Technical Memorandum #1

Date: August 22, 2022 **Project No.:** 300053263.1000

Project Name: 60 Dundas Street East Waste Management Planning Services

Enclosure(s) Tower A Waste Room and Collection Point Layout (Figure 1)

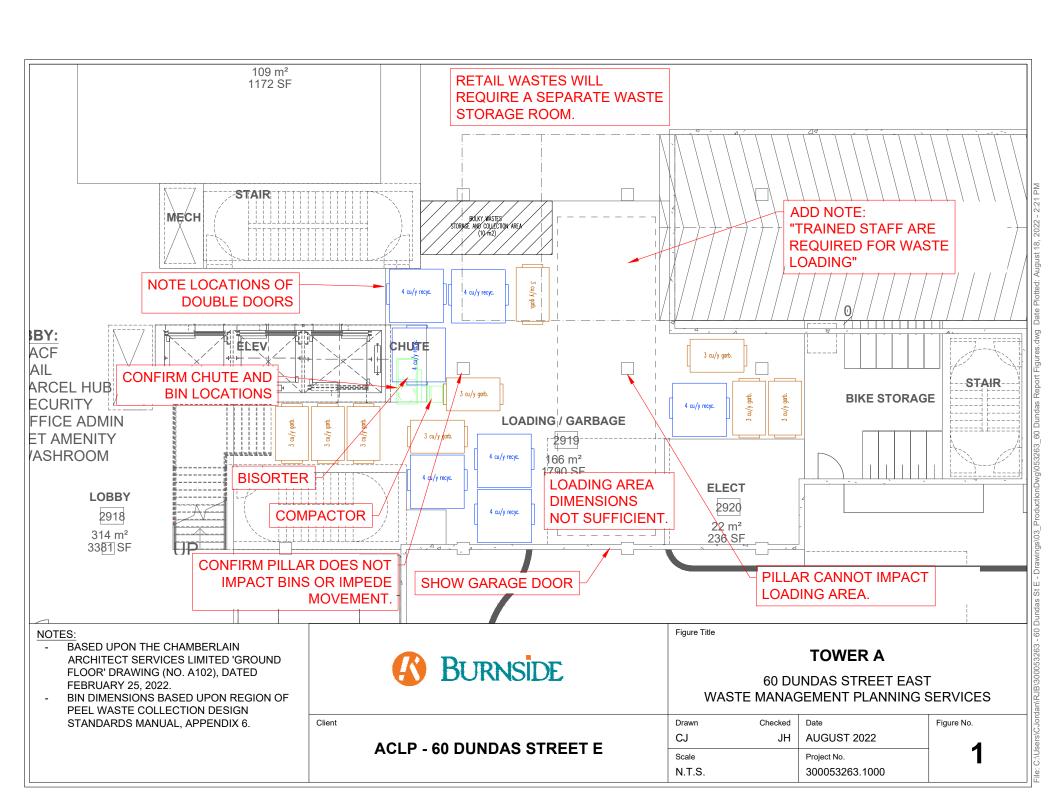
- 15. Although the Waste Storage Room for Tower A has sufficient space to store the required bins, collection will not work even with staff assistance. There is not enough space to move full and empty bins around during collection periods (see Figure 1).
- 16. A minimum 7.5 m overhead clearance height must be provided from the concrete pad. It must be clearly noted on the Site Plan, being free of obstructions (i.e., sprinkler heads, wires, etc.).
- 17. The grade of the collection point must not be more than +/- 2%. This must be noted on your drawings.
- 18. Bollards or a concrete curb is required at the rear of the Collection Point to protect the structural wall from damage when Front-End Bins are picked up or returned in place by the Waste Collection Vehicle.

The Waste Room for Tower A is enclosed as Figure 1, and the Waste Room and collection point layout of Towers B and C is enclosed as Figure 2.

20. The attached Floor Plan Layout and Collection Point Sketches show the proposed container counts and layout within the Waste Storage Rooms under the current design. An additional bin for each waste stream has been included for each tower such that the chutes can remain active during collection. As the Waste Storage Room for Tower A does not have enough room to incorporate an additional recycling bin, this has been included in Tower B and C's room. This may be transferred to Tower A as necessary.

Towers B & C Waste Room and Collection Point Layout (Figure 2) Peel Region Waste Collection Design Standards (Appendix 4)

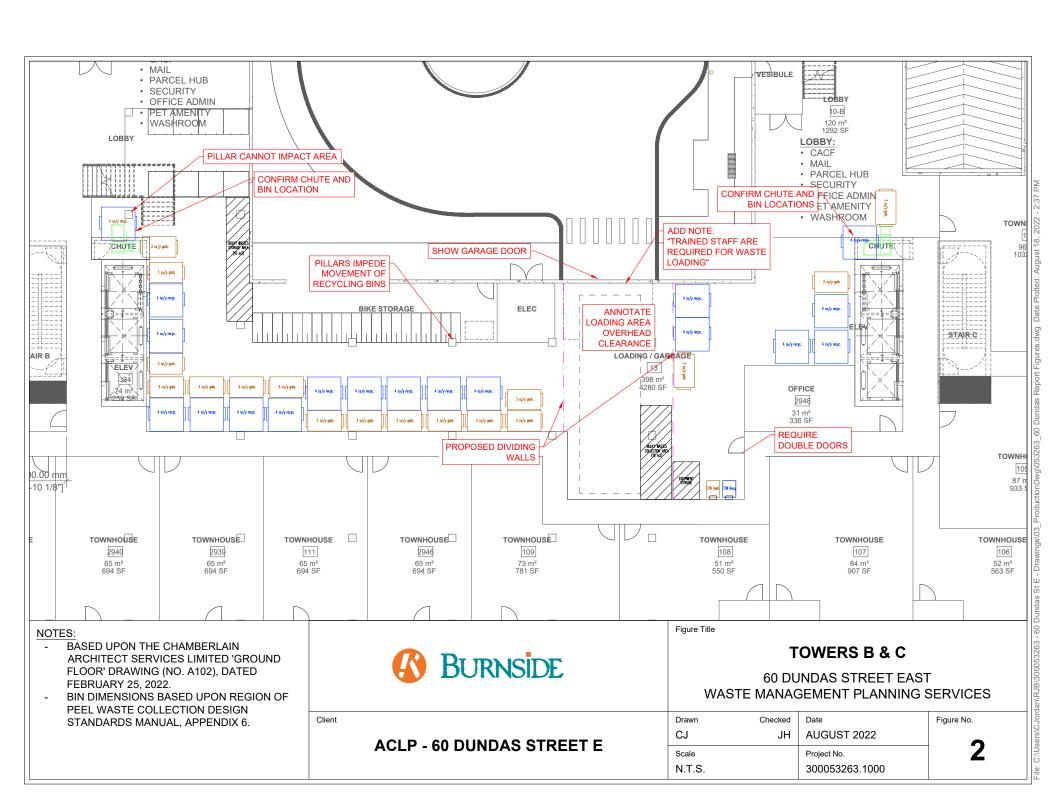
- 4. Bi-sorters will require space to allow for a compactor for garbage alongside front-lift garbage and recycling bins. Existing locations (particularly the chutes within Tower B and C's waste storage room) appear tight/unfeasible for the required infrastructure and
